SUBJECT: DRAFT REGION-TO-AREA SCREENING METHODOLOGY

Draft Region-to-Area Screening Methodology Document

Errata Sheet

**Figure 3. Crystalline Repository Project Report Schedule
Leading to Initiation of Area Phase Field Work**

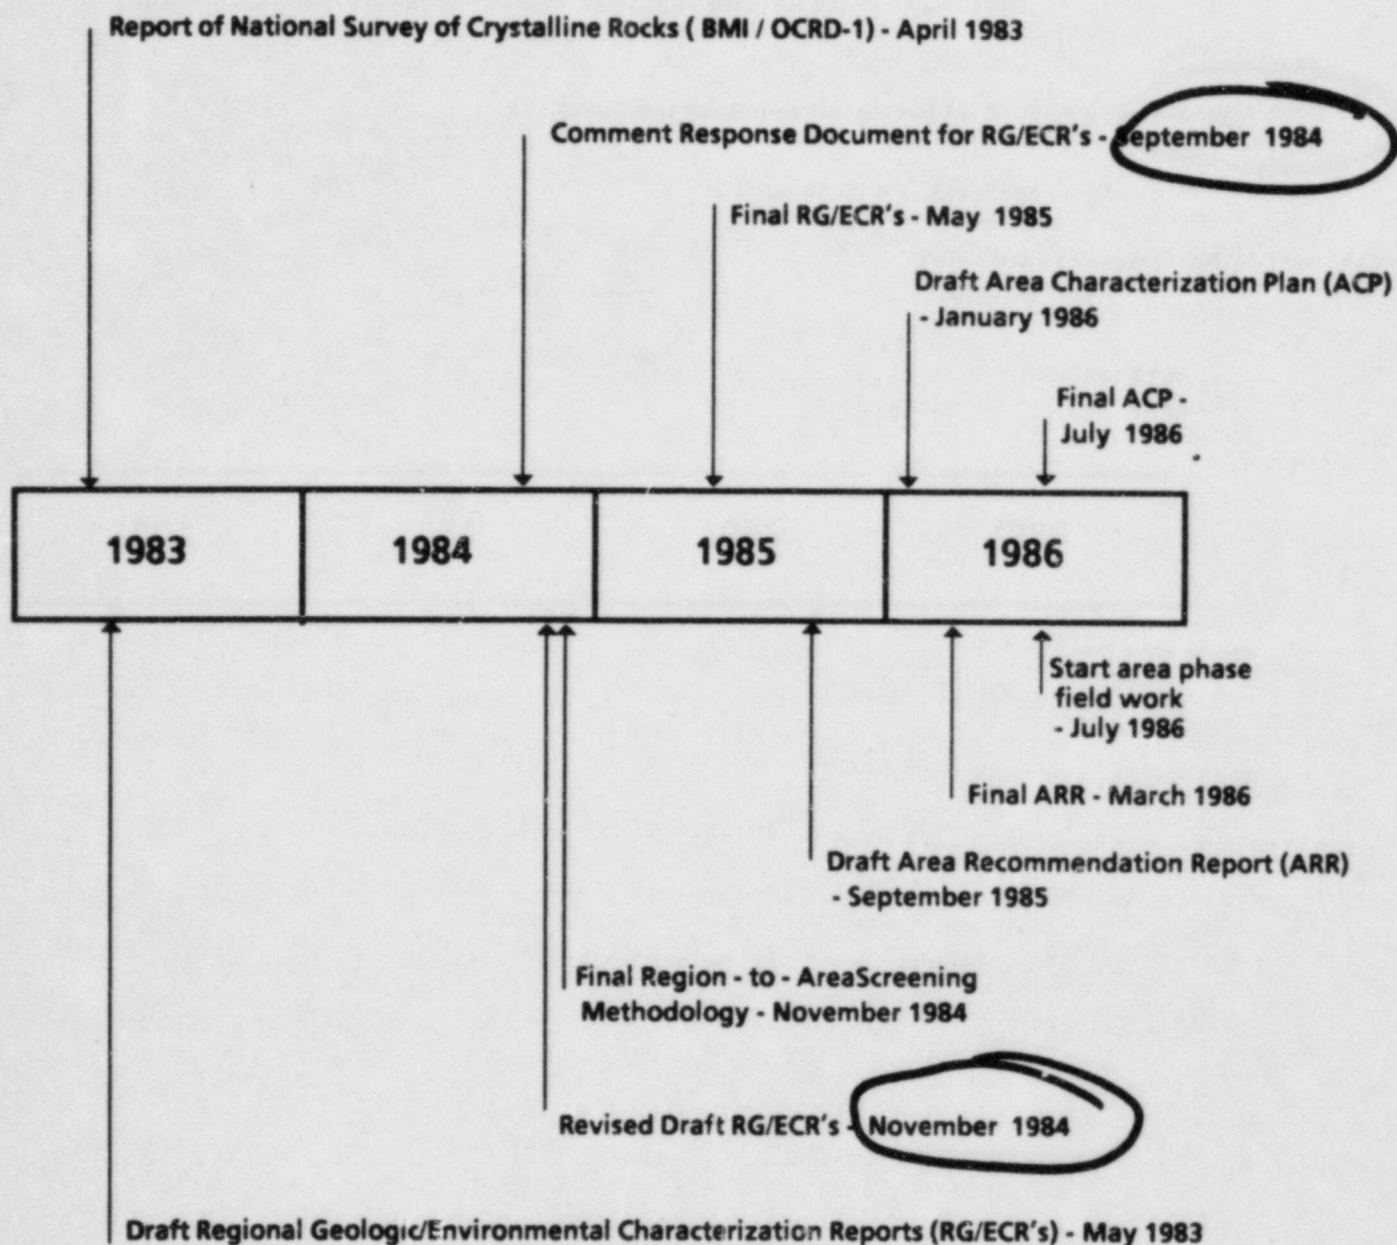
1. Page 11 - a new Figure 3 is attached.
2. Page 56, third paragraph, line 2 - "10 CFR 960.4-2-8-1(b)" should be "10 CFR 960.4-2-8-1(b)(1)".
3. Page 57, third full paragraph, line 1 - "Low Population Density Around Site" should be "Remoteness of Site From Highly Populated Areas."
4. Page 57, third full paragraph, line 3 - "Section 5.3.10" should be "Section 5.3.11".
5. Page 57, after third full paragraph - insert the following:
